OUR REF: CA 3504/2014 (prev 8/7/1815) 423040

**REQUEST TO CHANGE APPROVAL AND EXTEND RELEVANT PERIOD FOR
COMBINED APPLICATION 40-52 MITRE STREET, CRAIGLIE**

40-52 Mitre Street, 42-44 Mitre Street and 46-52 Mitre Street, Craiglie

Request to change approval and extend relevant period for the reconfiguring a Lot component of the Combined Application

| THIS DRAWING IS UNFIT FOR USE UNLESS THE INTENT OF WHICH ARE FULLY AND CORRECTLY UNDERSTOOD. THIS DRAWING IS UNFIT FOR USE UNLESS THE INTENT OF WHICH ARE FULLY AND CORRECTLY UNDERSTOOD. | | | | TITLE | LAYOUT | PROJECT | MANGO BEACH | WIND CLASSIFICATION - C2 |

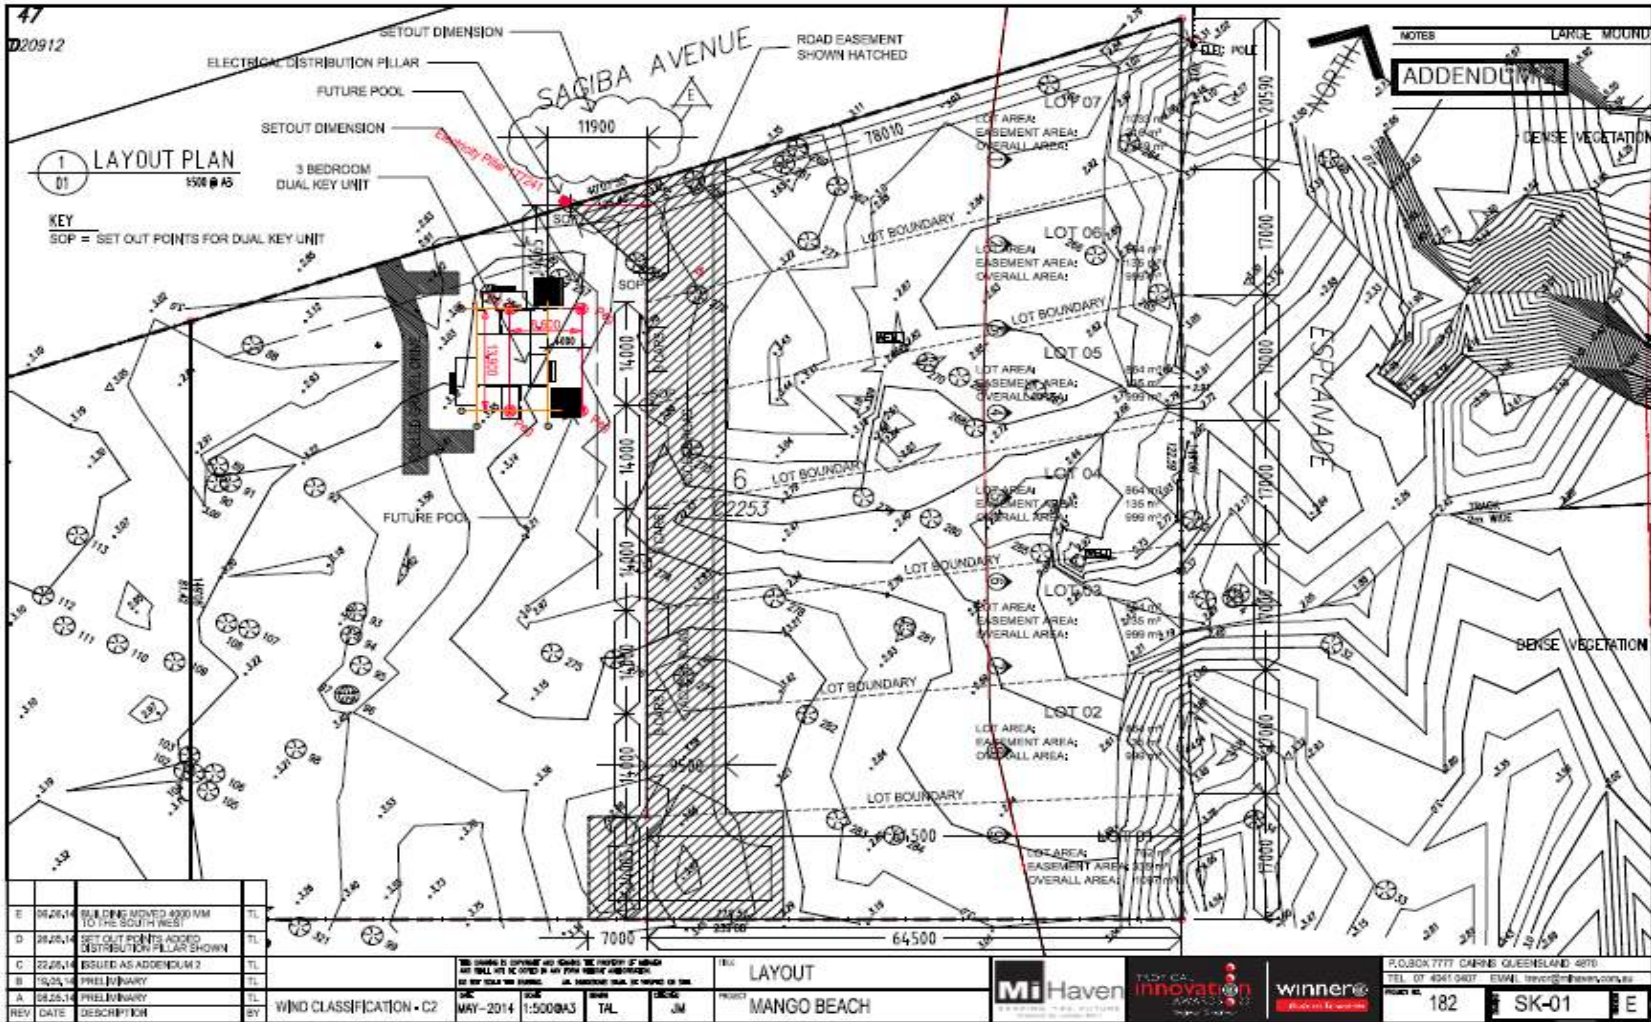
| E | 06.26.14 | BUILDING ADDED 4000 MM TO THE SOUTH WEST | TL |
| D | 06.26.14 | SET OUT POINTS ADDED DISTRIBUTION PILLAR SHOWN | TL |
